UNITED STATES PATENT AND TRADEMARK OFFICE

APPLICATION NO.	FILING DATE	FIRST NAMED INVENTOR	ATTORNEY DOCKET NO.	CONFIRMATION NO.
10/634,269	08/05/2003	Ming Gao Yao	12553/73	7073

Office Action Summary	Application No. 10/634,269	Applicant(s) YAO ET AL.	
	Examiner Mark Blouin	Art Unit 2627

EXAMINER'S DRAWING

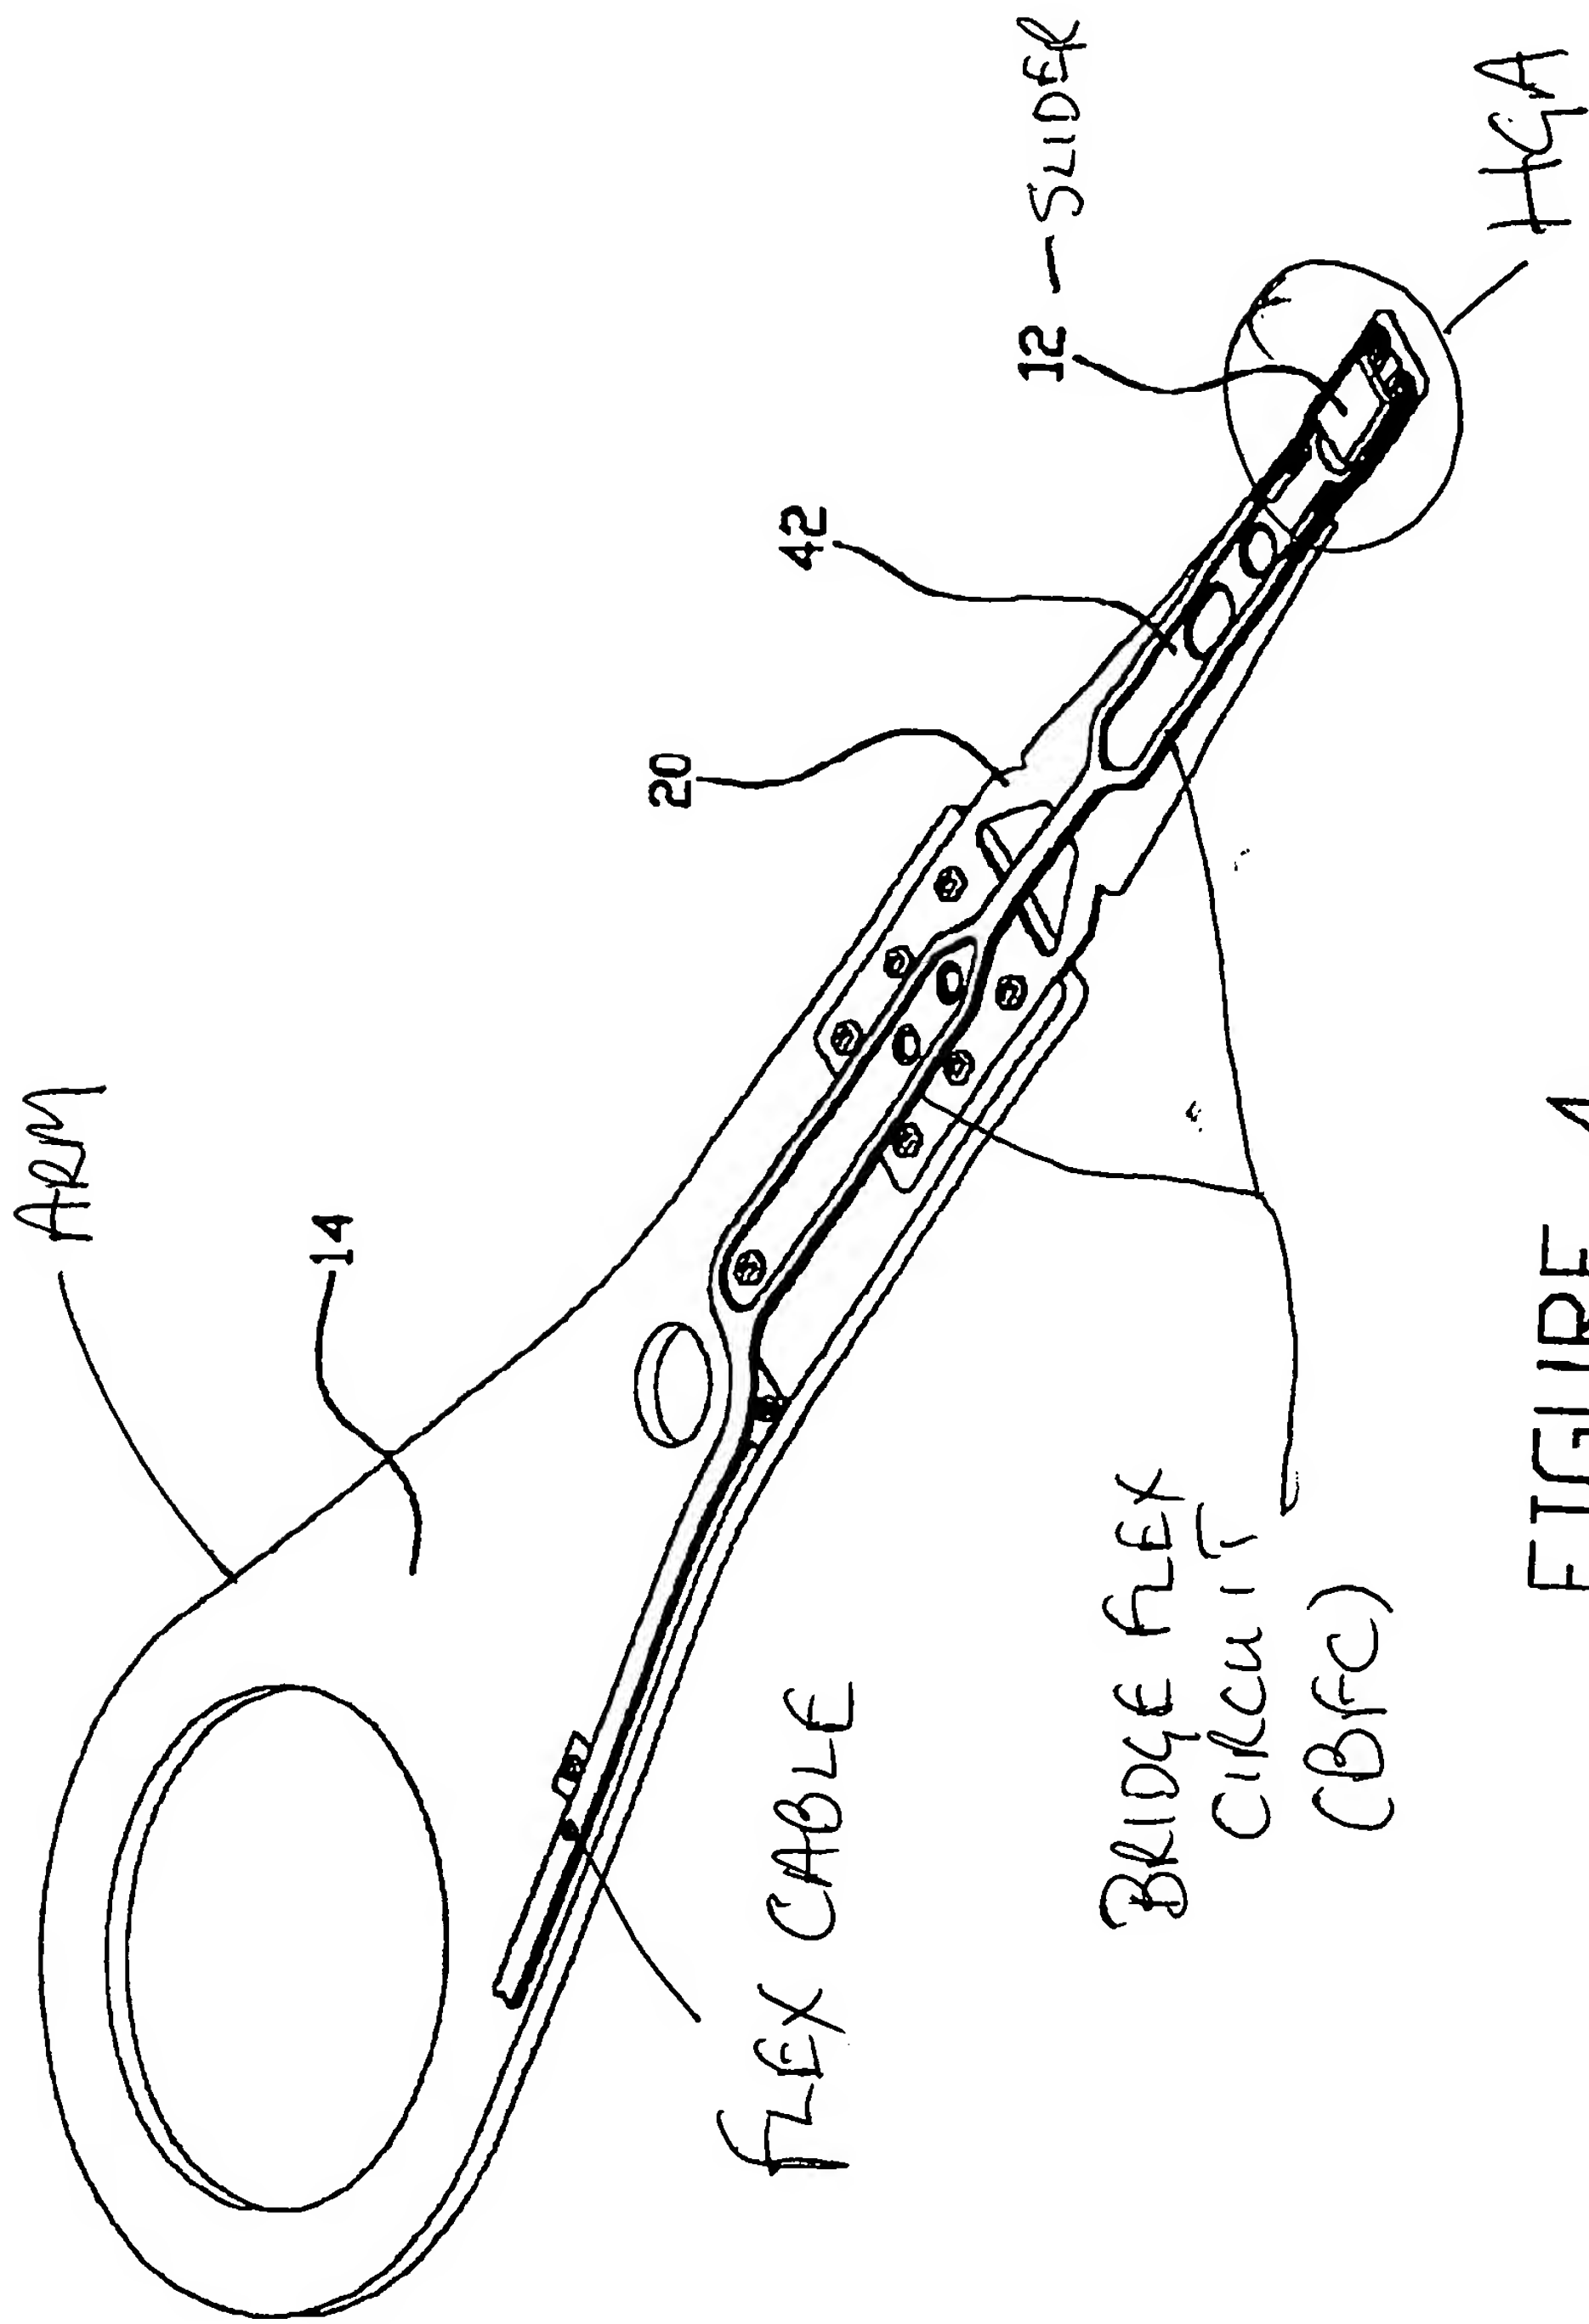
2. Claims 1-4,10-13, and 19-32 are rejected under 35 U.S.C. 102(e) as being anticipated by Detjens et al (US 6704163).
3. Regarding Claims 1 and 10, Detjens et al shows (Figs. 1-4) a system for a magnetic head arm assembly (HAA) comprising: a first component (20) having a first cavity (22) to be coupled to an arm portion (14) having an arm cavity (32) via a pin element (16) welded between said first component and said arm portion, wherein said first component is selected from the group consisting of a head suspension portion and a flex cable portion (See Examiner's Drawing).

4. Regarding Claims 2 and 11, Detjens et al shows (Figs. 1-4) the system, wherein said head suspension portion is a hard disk drive head gimbal assembly (HGA) (Col 1, line 46 - See Examiner's Drawing).

5. Regarding Claims 3 and 12, Detjens et al shows (Figs. 1-4) the system, wherein said flex cable portion (See Examiner's Drawing) is a hard disk drive (Col 1, lines 16-20) flex cable.

7. Regarding Claims 19 and 27, Detjens et al shows (Figs. 1-4) a system for a magnetic head arm assembly (HAA) comprising: a first component (14) to be coupled to a second component (20) via welding said first component to said second component, wherein said first component is selected from the group consisting of a head suspension portion, a flex cable portion, and a flex circuit portion, said second component is an arm portion (See Examiner's Drawing).

8. Regarding Claims 20 and 28, Detjens et al shows (Figs. 1-4) the system, wherein said first component (14) is a hard disk drive slider frame (a frame supporting the slider) and said second component is selected from a group consisting of a hard disk drive head gimbal assembly (HGA), and a hard disk drive slider (See Examiner's Drawing).

9. Regarding Claims 21 and 29, Detjens et al shows (Figs. 1-4) the system of claim, wherein said head suspension portion is a hard disk drive head gimbal assembly (HGA) (See Examiner's Drawing).

10. Regarding Claims 22-24, and 30, Detjens et al shows (Figs. 1-4) the system, wherein said flex cable portion is a hard disk drive flex cable, said flex circuit portion is a hard disk drive bridge flex circuit (BFC), and said arm portion is a hard disk drive arm (See Examiner's Drawing).
